REMARKS

Claims 1-4 stand rejected under 35 U.S.C. § 102(b) as being anticipated by Sweet (U.S. Pat. No. 3,757,818). This rejection is respectfully traversed.

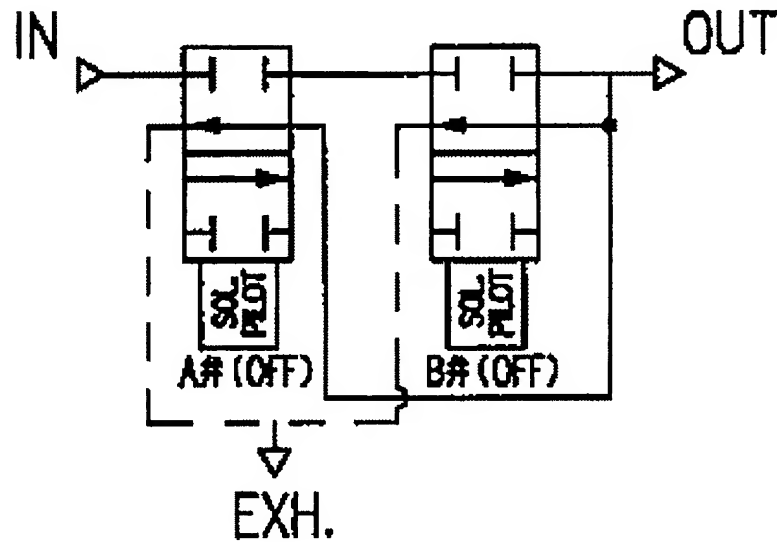
(2) when the first pilot valve is energized and the second pilot valve is de-energized, the inlet port, the outlet port, and the exhaust port are closed;

(3) when the first pilot valve is energized and the second pilot valve is energized, the outlet port and the exhaust port are connected, and the inlet port is closed.

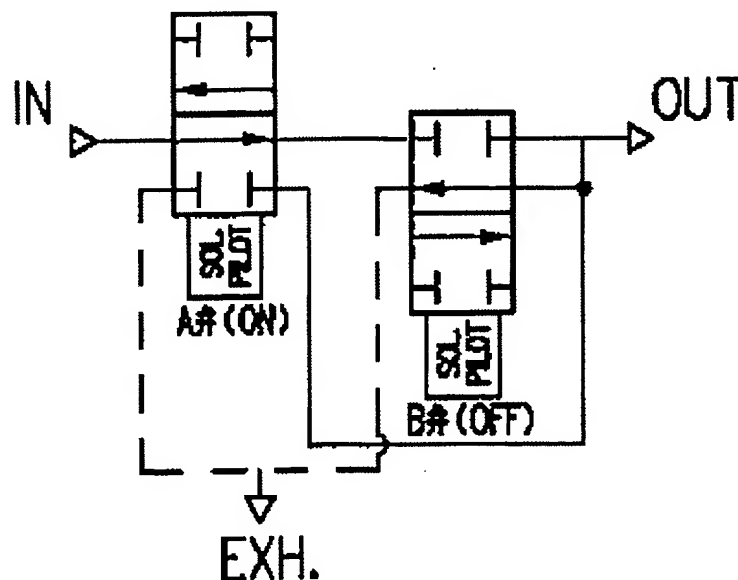
(1) when both the first pilot valve and second pilot valve are de-energized, the outlet port and the exhaust port are connected, and the inlet port is closed.

(see the drawing below)

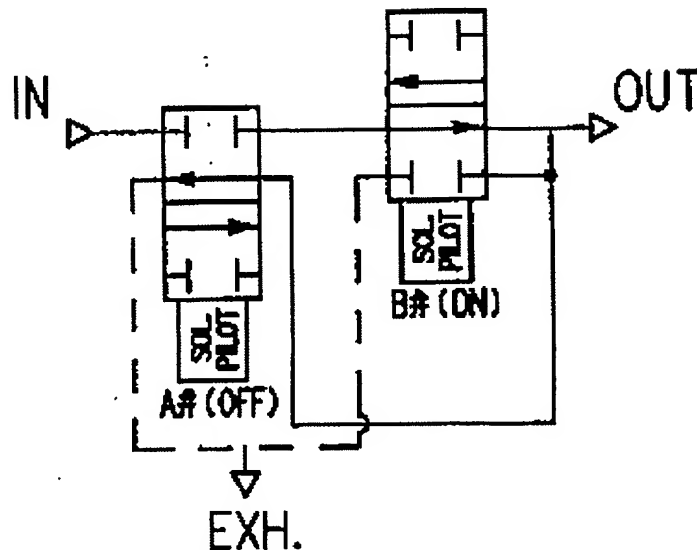
(2) when the first pilot valve is energized and the second pilot valve is de-energized, the outlet port and the exhaust port are connected, and the inlet port is closed.

(see the drawing below)
